Re: 7-Eleven #1049078 (SP2021-021)
4949 S. Goliad Street
Rockwall, TX 75032
Variance Request Letter

TO: Mayor and City Council
FROM: Andrew Reyna, *Planner*
DATE: December 6, 2021
SUBJECT: MIS2021-015; *Variance Request to the Utility Standards for 7/11*

SITE PLAN

SHEET
C3.1

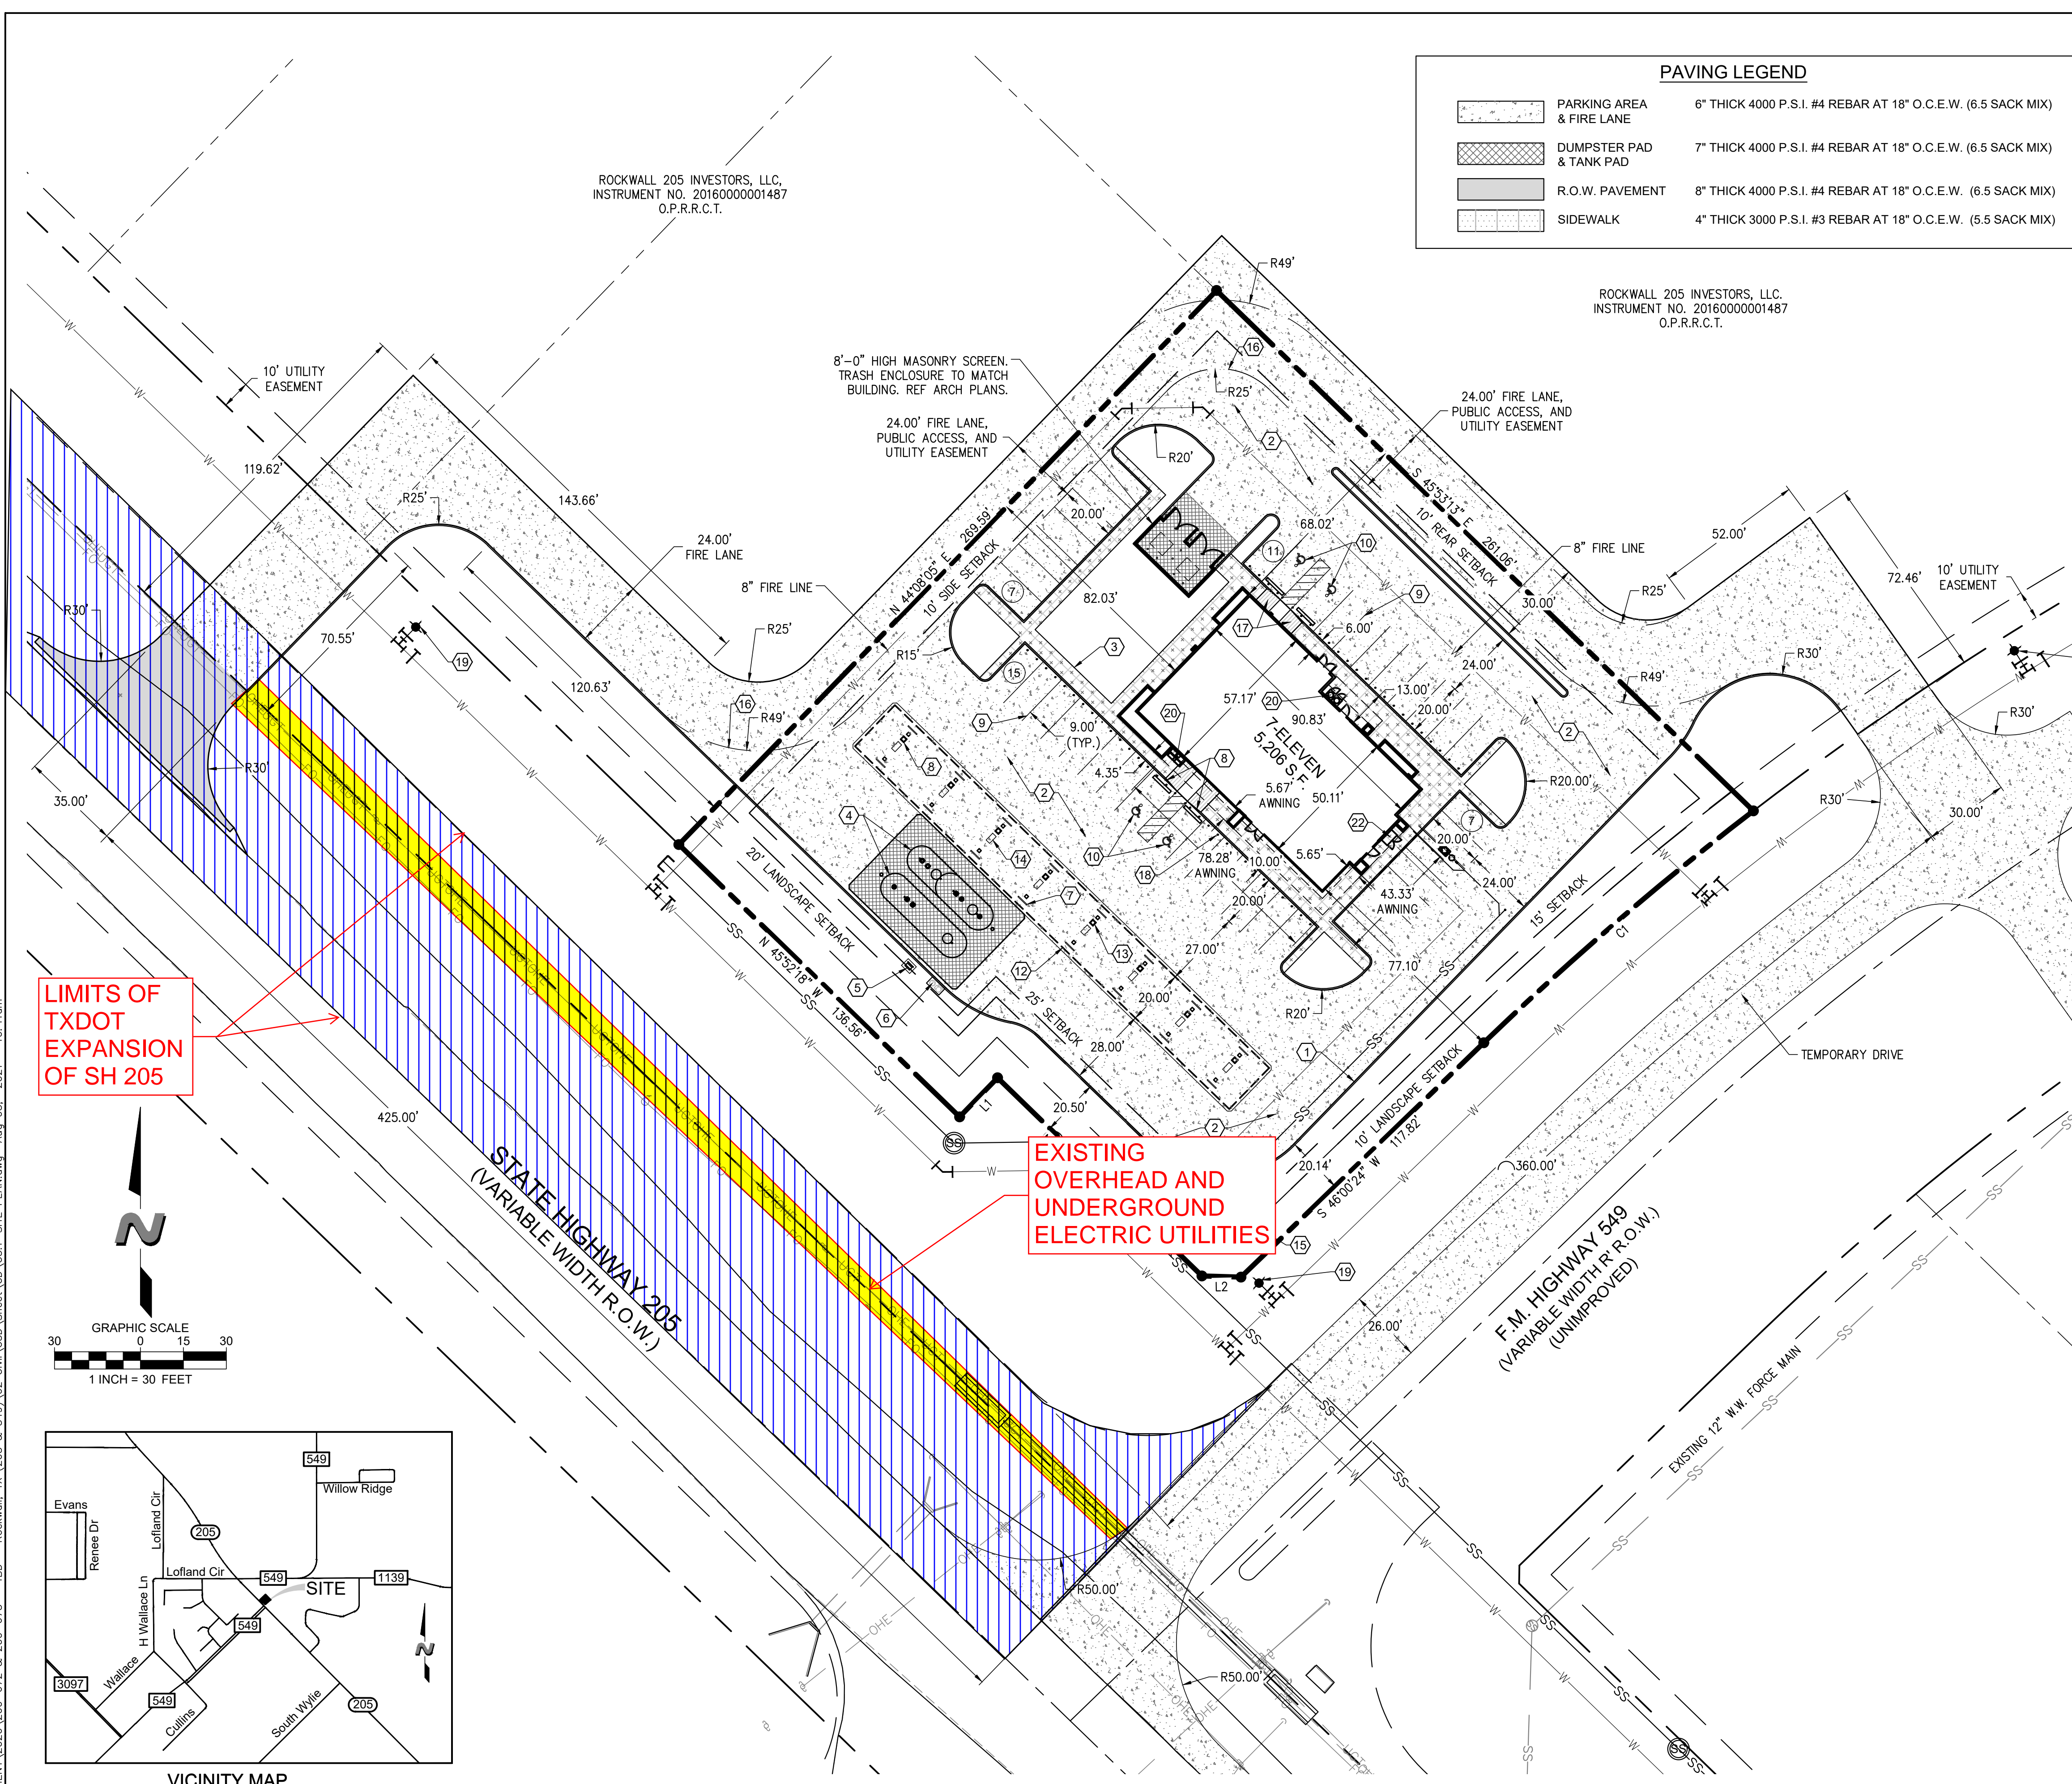
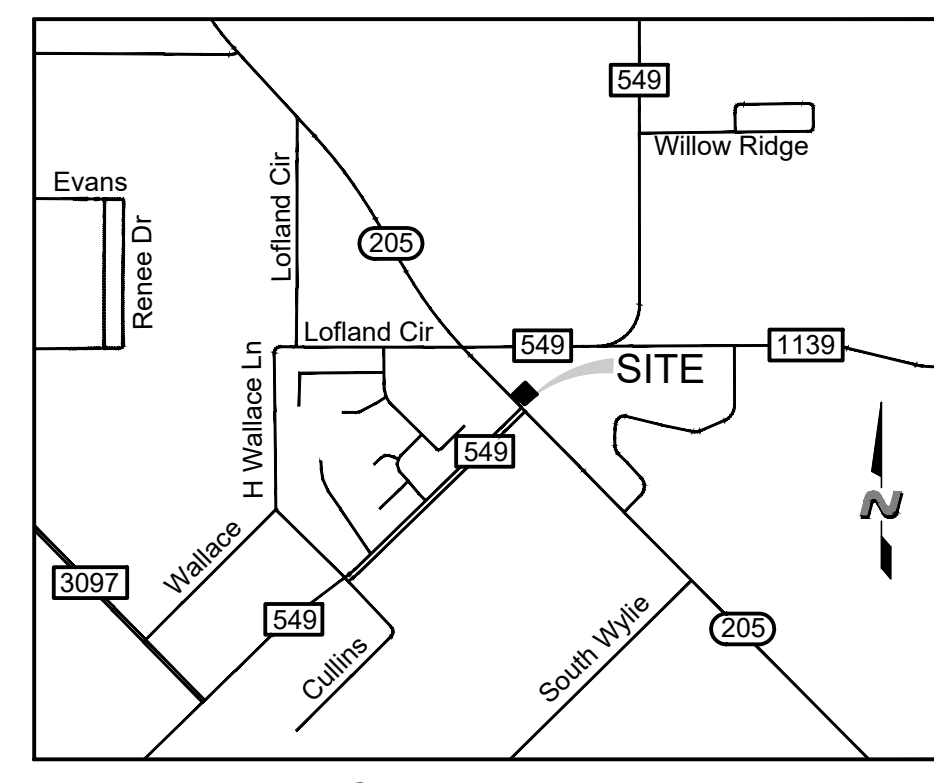
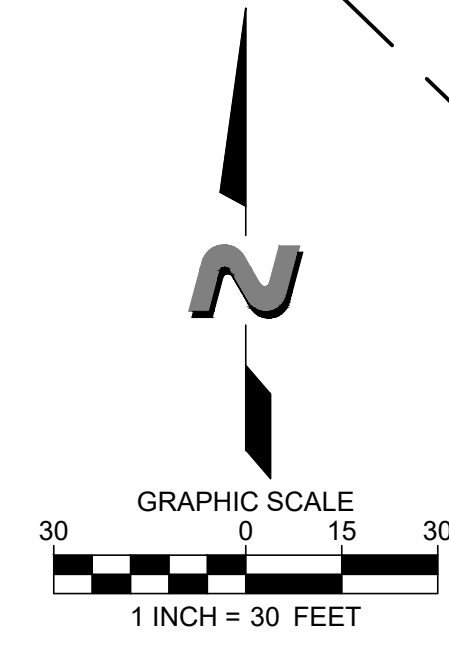
The applicant is requesting the City Council grant a variance to the underground requirements to allow overhead powerlines along SH-205. In the applicant's letter, the applicant has stated that Farmers Electric Cooperation would need to relocate these lines in the future, and based on this they believe it would be complicated to underground this portion of the utilities. According to Section 09.02, *Variances to the General Overlay District Standards*, of Article 11, *Development Applications and Review Procedures*, of the Unified Development Code (UDC), "...an applicant may request the Planning and Zoning Commission grant a variance to any provision contained in Section 06.02, *General Overlay District Standards*, of Article 05, *District Development Standards*, where unique or extraordinary conditions exist or where strict adherence to the technical requirements of this section would create an undue hardship." The code goes on to state that two (2) compensatory measures that *directly offset* the requested variance shall be provided. In this case, the applicant has stated that they are willing to provide [1] an increased landscape buffer along FM-549, [2] increased landscaping, [3] increased natural stone, [4] increased architectural elements, and [5] increased glazing area (*i.e. faux windows*). Staff should point out that many of these compensatory measures were already used to justify the variance to the roof standards on the original site plan case, and that the increased glazing was a recommendation by the Architectural Review Board (ARB) if the roof variance was granted. Additionally, the proposed compensatory measures do not appear to directly off-set the requested variance. It should also be noted that in previous cases

for similar requests the City Council and Planning and Zoning Commission have not approved variances relating to the undergrounding utilities due to the potential of creating a precedence; however, variances are discretionary decisions that are considered on a case-by-case basis by the City Council pending a recommendation from the Planning and Zoning Commission. Staff is obligated to should point out that if this property is granted a variance it is part of a larger commercial tract, and the remainder of the tract would be required to underground the utilities at the time of development. If this is the case, this could create an aesthetically inconsistent frontage along SH-205.

In the attached packet staff has included a proposed utility plan showing the current and proposed location of the powerlines, and the applicant's letter. Staff should note that the approval of any variance in an established overlay district would require a $\frac{3}{4}$ -majority vote of the City Council (*i.e. members present at the meeting*) for approval.

On November 30, 2021 the Planning and Zoning Commission approved a motion to *deny* the Variance Request to the Utility Standards by a vote of 5-0, with Commissioner(s) Chodun and Moeller absent.
